Subject: S.16 Planning Application No. A/YL-SK/469 - Submission of Further Information (1)

**Application for Permission under Section 16 of the Town Planning Ordinance (Cap.131)
Proposed Temporary Open Storage of Construction Materials and Construction Machineries
with Ancillary Facilities and Associated Filling of Land for a Period of 3 Years
in “Agriculture” Zone at Various Lots in D.D. 106 and Adjoining Government Land, Shek Kong, Yuen
Long
(Planning Application No. A/YL-SK/469)**

Submission of Further Information (1)

Response-to-Comments Table

Drainage Proposal - LAYOUT

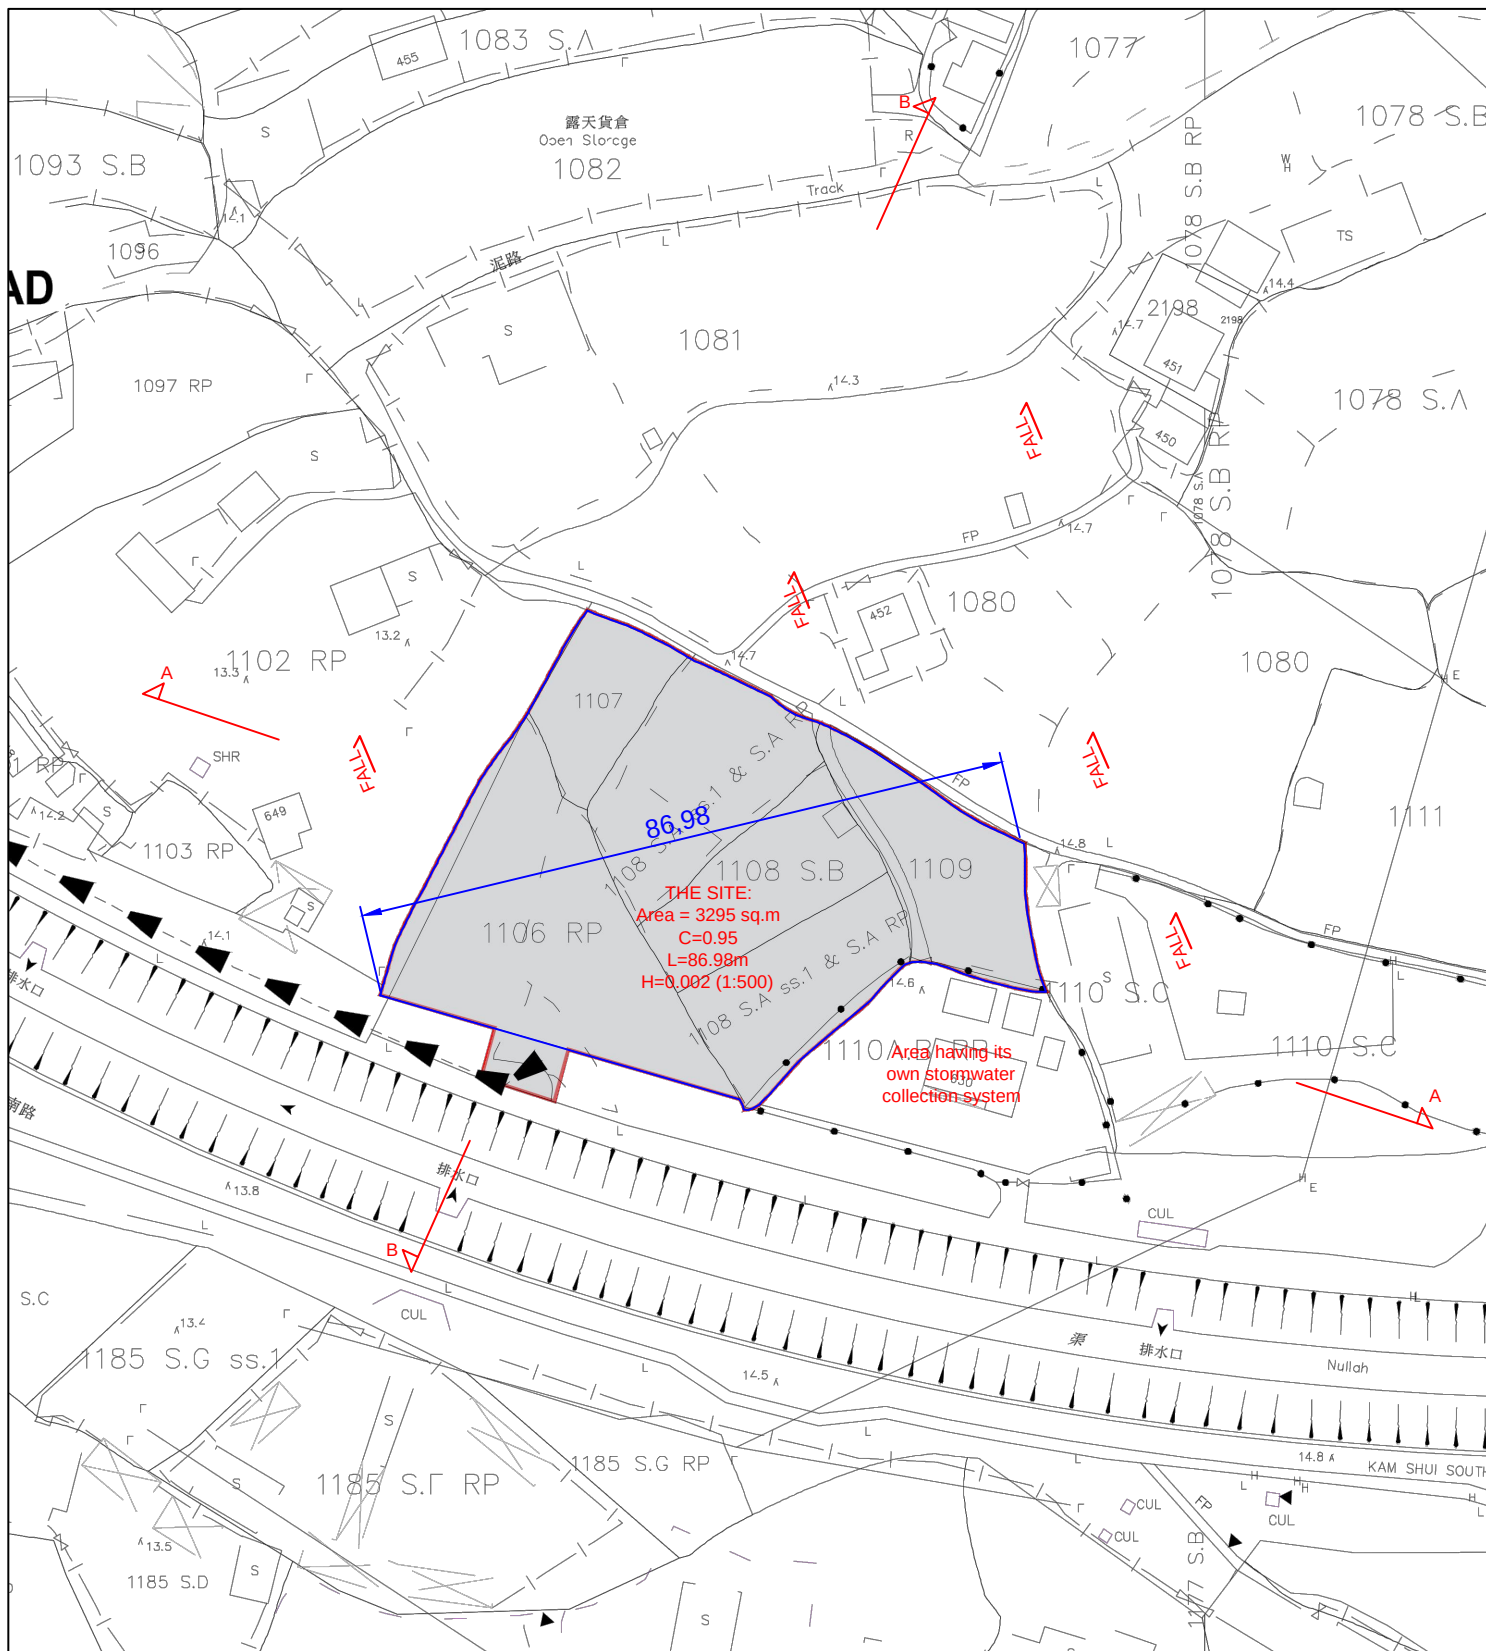
(iv) In general, only one catchpit with sand trap/terminal manhole will be provided near the site boundary and located within the private lot for each application site before the collected runoff is discharged to the public drainage facilities. Please review the proposed arrangement accordingly.	Trap facility is provided in CP6 only.

(v) Please indicate the invert level at the proposed start points of peripheral surface channels on the drainage plan in Appendix D for reference.	It is indicated.
	(vi) The development should neither obstruct overland flow nor adversely affect existing natural streams, village drains, ditches and the adjacent areas, etc.	Noted.
	(vii) The applicant should consult DLO/YL and seek consent from the relevant owners for any drainage works to be carried out outside his lot boundary before commencement of the drainage works.	Noted.
	(viii) The applicant should submit form HBP1 to this Division for application of technical audit for any proposed connection to DSD's drainage facilities.	Noted and agreed.

Drainage Proposal -
SECTIONS

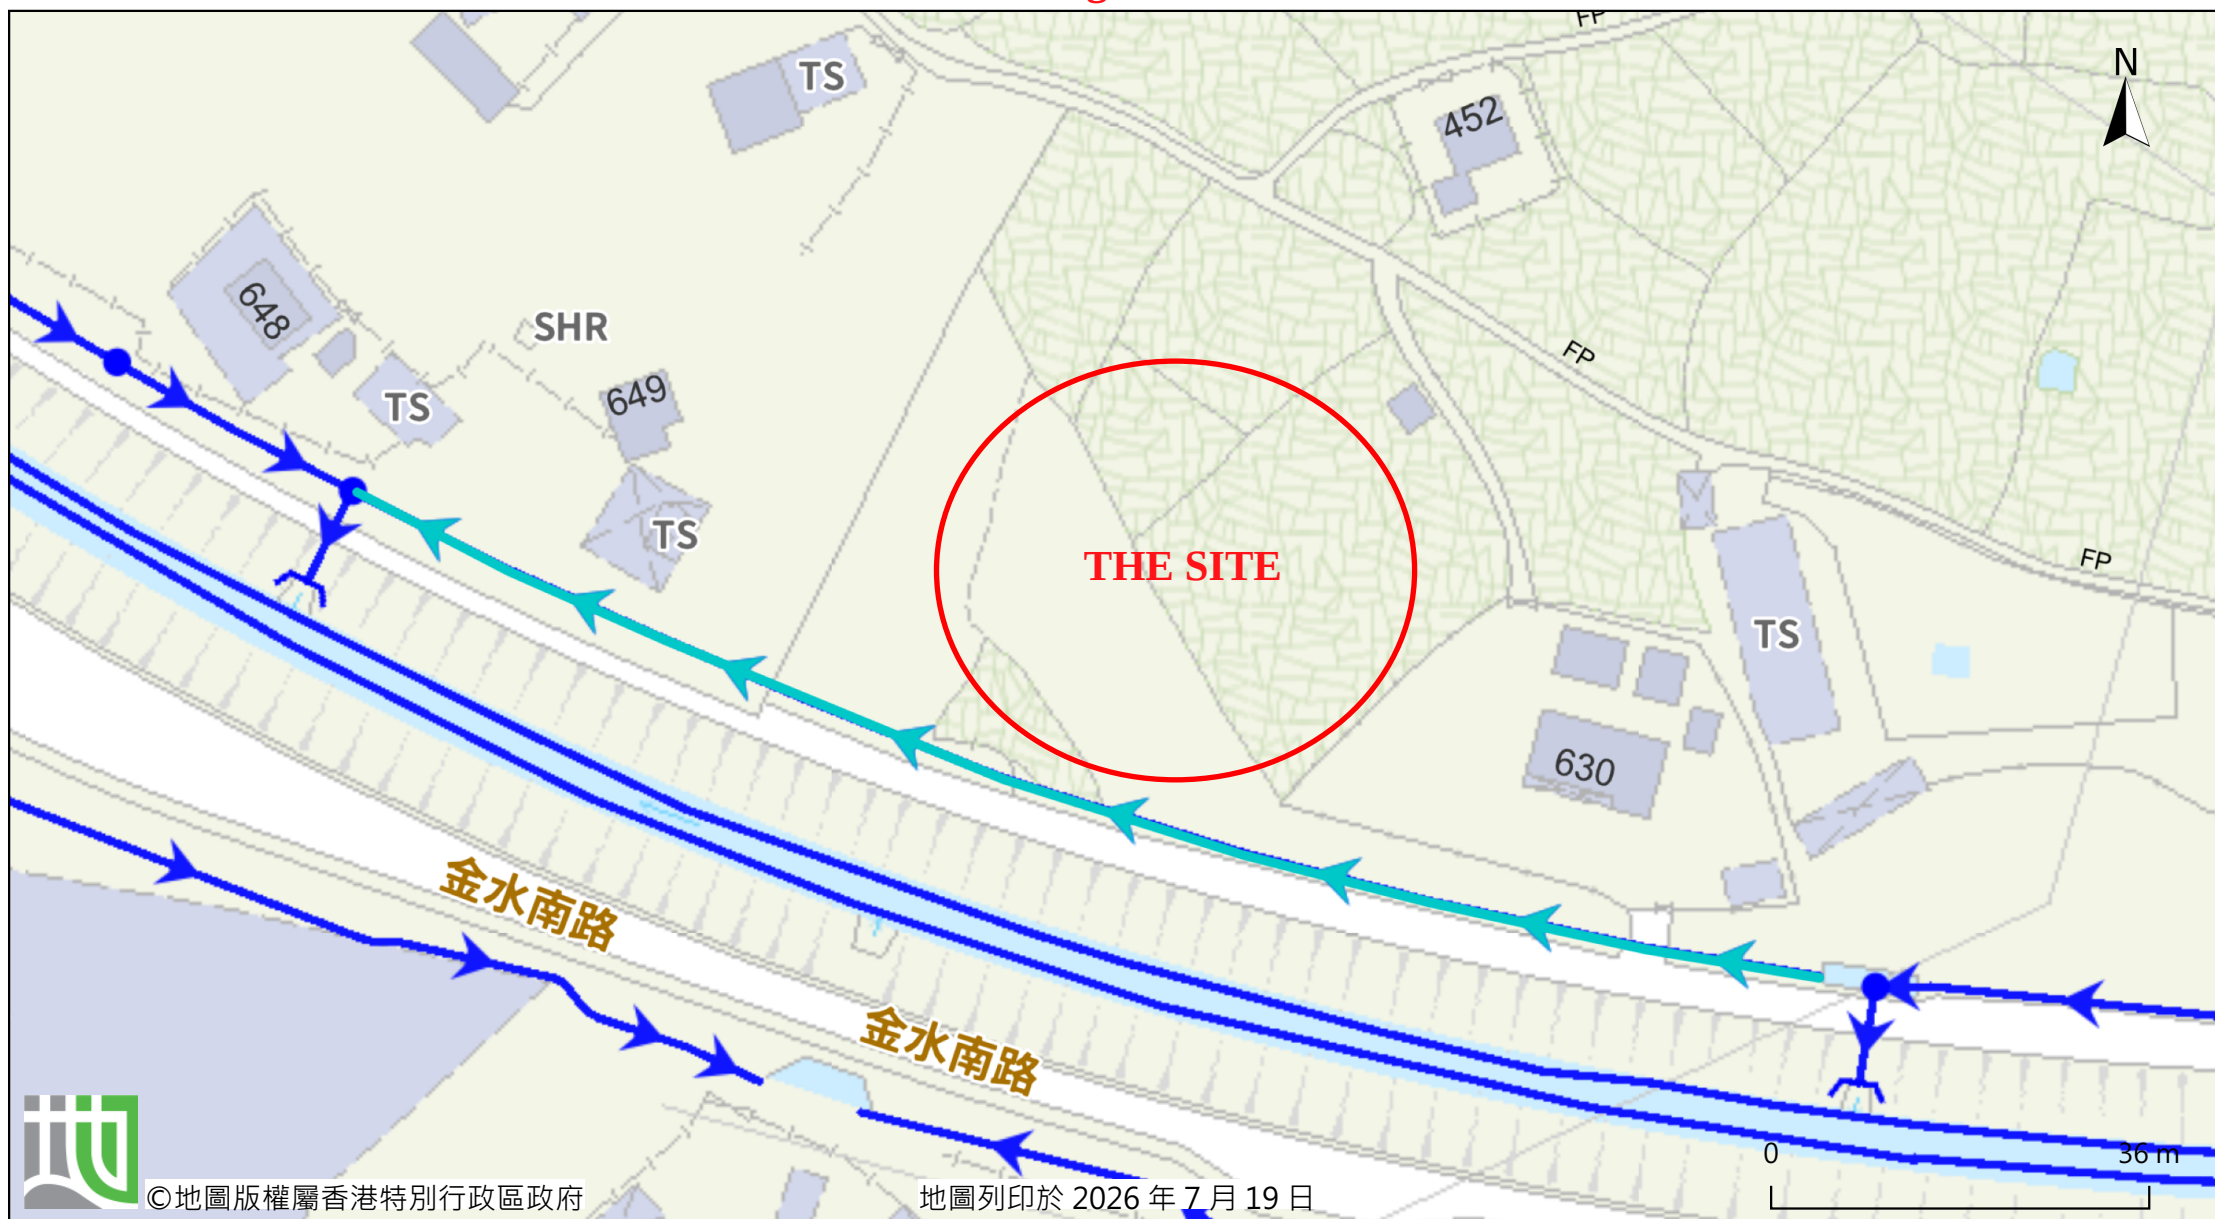
No.	Comments	Responses
1	Chief Engineer/Mainland North, Drainage Services Department (Contact Person: Mr. Jeff TSE), dated 24.9.2026 (i) According to the drainage plan and Section B-B, there is an existing DSD's 750mm u-channel located at Kam Shui South Road and it may be affected/disturbed due to the proposed levelling works, which is not desirable from public drainage point of view. Please review.	In order to suit the level of the egress/ingress of the site, the cover level of the existing 750UC within the site is proposed to be modified to match with that of the egress/ingress level. CP5 and CP6 is provided. The flow would not be affected.
	(ii) Please make reference to the latest Technical Note No. 1 issued by DSD for more details in preparing the drainage proposal. In view of the site area, please consider upgrading all drainage facilities size accordingly.	Noted.
	(iii) Peripheral surface channels shall be provided along the site boundary at the existing/original ground level (instead of the revised ground level) to collect the surface runoff accrued on the application site and to intercept the overland flow from the adjacent lands. Please review the level of the proposed peripheral surface channels in cross sections accordingly.	The cover level of the proposed peripheral channel is at the existing level. Cross sections are revised accordingly.
